Beauregard Update

Compiled Community Comments:

Comments on the Beauregard Small Area Plan Draft Dated March 27, 2012

Provide a REAL Park on the Foster-Fairbanks Tract a.k.a. Shirley Gardens a.k.a. Upland Park

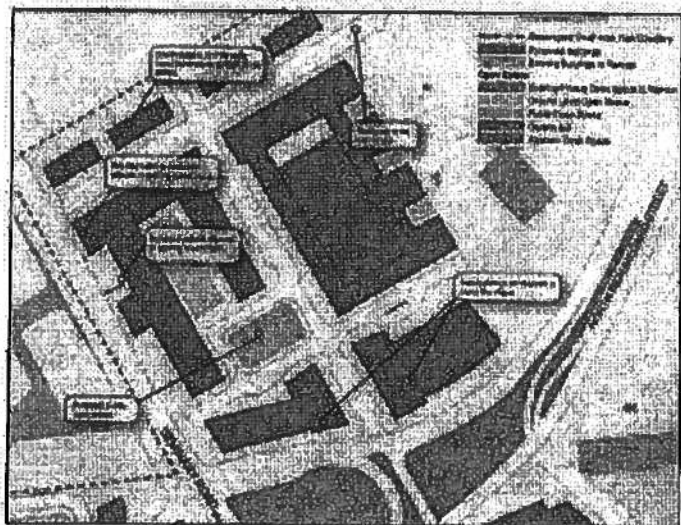
- The Draft Plan references 45 acres of "new open space" that is defined extremely loosely and includes spaces between sidewalks and streets and spaces in traffic islands. This characterization is deceptive and obfuscates the many acres of "old open space" that will be built on.
- Adding 7.2 acres of land to Dora Kelley Nature Park is laudable, but the City has not given us a cost benefits analysis of this property transfer. How much will the City lose in tax revenue? How much is this proffer valued at?

- Since the tennis courts at Sanger and Beauregard are in a flood plain can they actually be converted to an artificial turf field? If it is allowed, will this conversion require a French drainage system with a pump?
- The \$3 M proffered for landscaping and streetscape is insufficient to mitigate the impacts of the proposed development on Dora Kelley Nature Preserve and Holmes Run. Like the BRAC building did to Winkler Preserve, these projects will generate storm-water runoff that will threaten existing parks and streams and they should proffer additional funds for mitigation as opposed to just streetscape.
